RESPONSE TO COUNCIL LETTER UNSW HEALTH TRANSLATION HUB (SSD-10822510)

This response has been prepared to address the letter received from Randwick City Council dated 14 October 2021.

Figure 1 – Response to Council’s footpath design

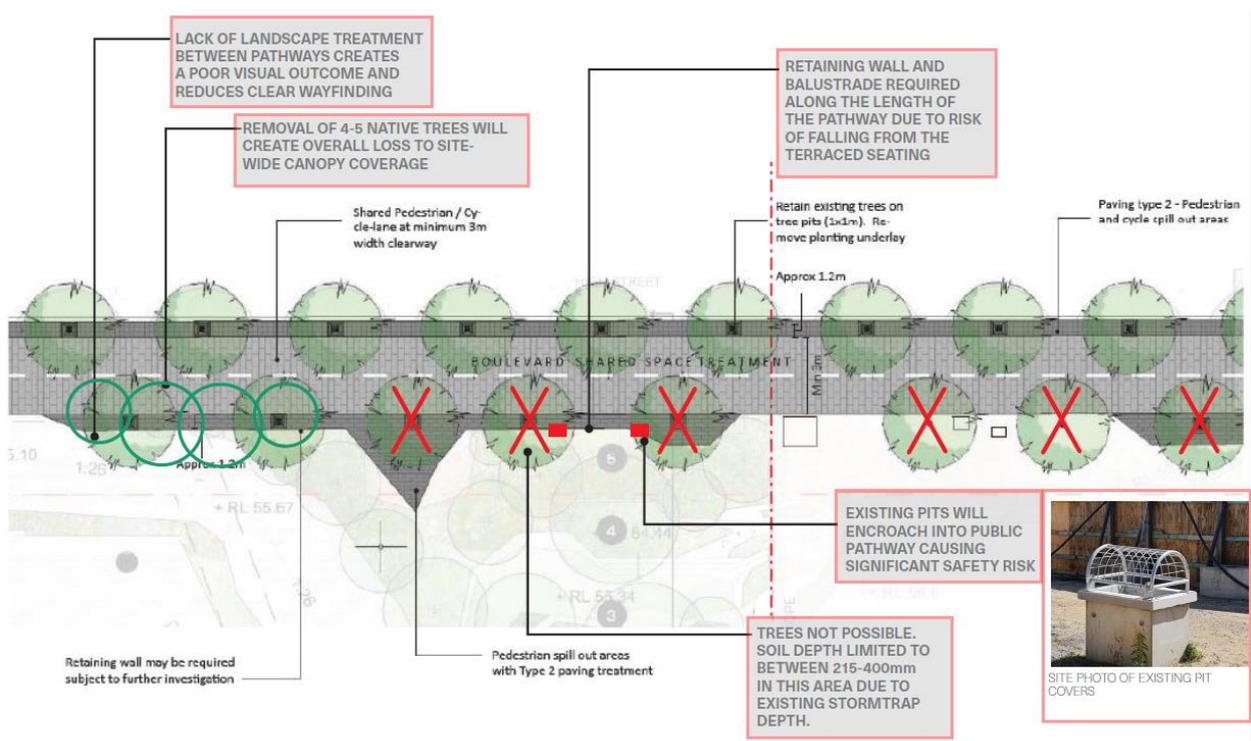
Council has maintained that the High Street footpath should be widened by 500mm to the south, to provide a footpath with a minimum width of 3m. Council has provided a draft sketch showing how this could be accommodated. Council has also provided a response to each of the points put forward in the RTS, and has suggested that the changes required to accommodate the widened pathway could be managed and would not hinder the successful delivery of the project.

- The need to integrate ramps and stairs within the overall landscape.
- Widening the footpath would result in the introduction of a 650mm retaining wall, visual clutter from additional handrails and balustrades, and the loss of trees from the landscape design. This would negatively impact the quality of the public domain, creating a series of hostile conditions on High Street which would diminish the seamless landscape transition from the High Street footpath to the public plaza. The trees that would be lost cannot be accommodated elsewhere in the site, and so canopy coverage would be reduced on the site.

- Widening the footpath would expose existing stormwater infrastructure that is unsightly and a potential safety hazard for pedestrians, introducing a liability risk (refer to inset image at **Figure 1**). The physical design of these inlets is unsightly and is best concealed by landscaping, as is the case with the proposed design solution. The introduction of cyclists to this pathway would heighten this risk (refer to discussion at **Section 2**).

As noted, Council has provided a sketch indicating how the widened footpath could be accommodated. A mark-up of the sketch, demonstrating the implications of the suggested design, is provided at **Figure 1**. The existing stormwater infrastructure that would be exposed is shown in the bottom right of the image. For comparison, the UNSW HTH landscape response is provided at **Figure 2**.
